UNITED STATES PATENT AND TRADEMARK OFFICE

APPLICATION NO.	FILING DATE	FIRST NAMED INVENTOR	ATTORNEY DOCKET NO.	CONFIRMATION NO.
10/538,413	06/10/2005	Helmut Rupp	2004P84076WOUS	3589

Office Action Summary

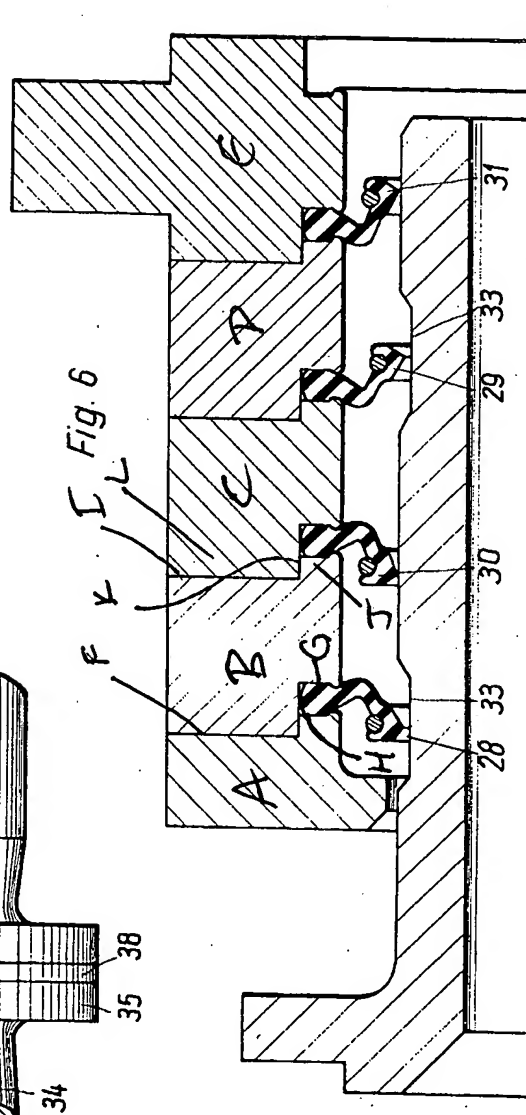
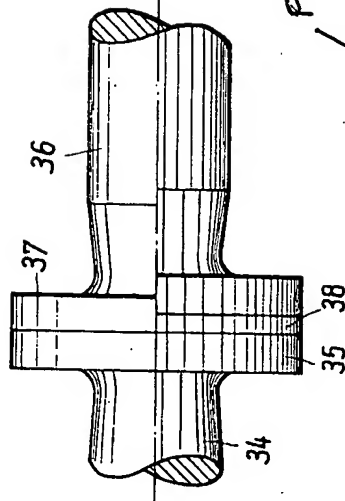
Note for reference characters A-M refer to the Examiner's Attachment A and for reference character Z refer to the Examiner's Attachment B.

Regarding claim 12, the Walter et al. reference discloses a seal (Fig. 6) sealing a gap between a rotor (e.g. 17) and a stator (e.g. 15), comprising:

a ring (e.g. 28-31) and at least two annular ring carriers (e.g. A-E) extending in the circumferential direction of the rotor (Fig. 6), each ring being fixed between a first end face (F) of a first brush carrier (e.g. A) and a second end face (G) of a second ring carrier (e.g. B), and the second ring carrier being directly fixed axially and radially to the first ring carrier (Fig. 6),

wherein the second ring carrier is fixed to the first ring carrier by an unreleasable snap connection (Fig. 6), including the ring being a lip ring (Fig. 6).

Regarding claim 13, the Walter et al. reference, as modified in claim 12, discloses a slot (H) being formed between the first brush ring carrier and the second brush ring carrier and the slot receiving the brush ring (Walter et al., Fig. 6).

Regarding claim 14, the Walter et al. reference, as modified in claim 12, discloses at least one brush ring carrier (B) having on its first end face (I) a shoulder with a circumferential slot (K) and at least one second brush ring carrier (C) having on its second end face (e.g. face of element C in contact with I) a continuous projection (I), with a latching nose (e.g. portion of element C latched to element J), and the projection and the latching nose of the second brush ring carrier cooperating with the shoulder and with the circumferential slot of an adjacently arranged first brush ring carrier (Fig. 6).

Regarding claim 15, the Walter et al. reference, as modified in claim 12, discloses at least one brush ring carrier (B) having on its first end face (I) a shoulder with a circumferential slot (K) and at least one brush ring carrier (C) having on its second end face (e.g. face of element C in contact with I) a continuous projection (I), with a latching nose (e.g. portion of element C latched to element J), and the projection and the latching nose of the second face of the at least one brush ring carrier cooperating with the shoulder and with the circumferential slot of an adjacently arranged brush ring carrier (Fig. 6).

Regarding claim 17, the Walter et al. reference, as modified in claim 12 and as best understood, discloses a circumferential slot (K) in a brushing ring carrier (B) and a latching nose (e.g. face of element C in contact with I).

Regarding claim 21, the Walter et al. reference, as modified in claim 12, discloses the brush seal being a radial seal (Walter et al., Fig. 6).

FIG. 7D

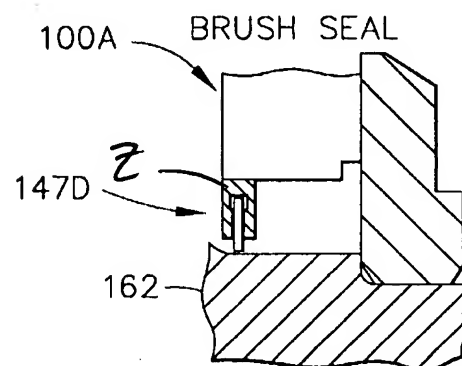
Regarding claim 18, the Walter et al. reference, as modified in claim 12 and as best understood, discloses the brush ring carriers having a support plate (e.g. Langston et al., Z) and the brush rings bearing axially against the support plate (Langston et al., Fig. 7D).

Regarding claim 19, the Walter et al. reference, as modified in claim 12, discloses the brush ring carriers having a protective ring (e.g. Langston et al., Z).

Regarding claim 20, the Walter et al. reference, as modified in claim 12 and as best understood, disclose the protective ring being radially elastic (Langston et al., Fig. 7D).
